Topic	Over check for clip removal cars having had E788 applied between 25th July and 16th August 2013
Market area	Worldwide Bentley (1WBE)
Brand	Bentley
Transaction No.	2035067/1
Level	EH
Status	Approval
Release date

Over check for clip removal cars having had E788 applied between 25th July and 16th August 2013

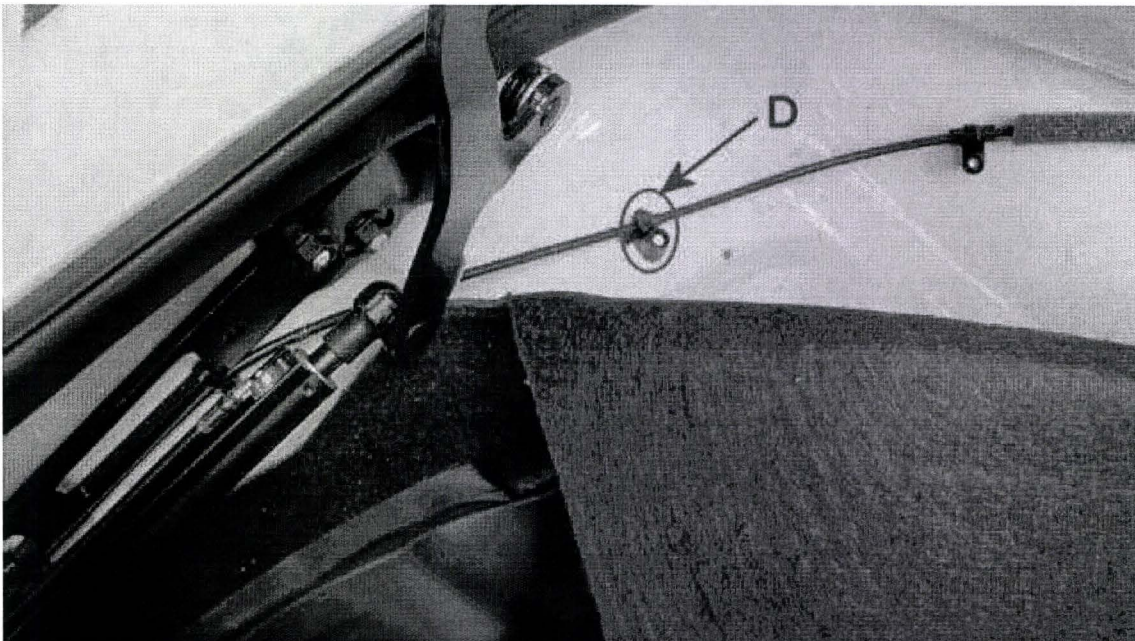
Due to an omission in the text of campaign document E788, *Convertible roof – revised clip arrangement – C flap Bowden cable (SC13/12) version 1*, one clip on each Bowden cable (two clips in total) that should have been deleted may still be present. Each specific VIN requiring this over check is listed in this document

Therefore at the next scheduled dealer visits check for the presence and if necessary remove the two relevant clips (D) detailed below. Version two of campaign document E788, published on the 16th August 2013, incorporates the detail for removal of these clips

Temporarily reposition the corner of the hood stowage compartment carpet to view point D, if present discard the clip securing the Bowden cable at point D perform this operation on both sides of the car. Reposition the corner of the hood stowage compartment carpet.
